ADA Curb Ramp New Construction Inspection Form (Perpendicular)

Nw Jackson school rd

24952.54

West union rd

PERPENDICULAR RAMP (PR)

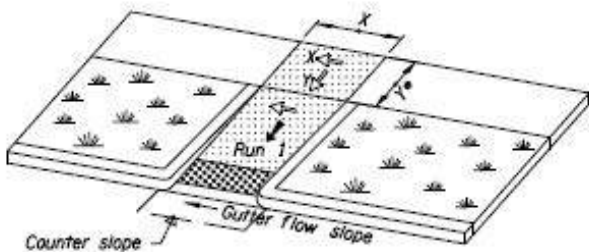
IITD tool joint in turn space ICRR
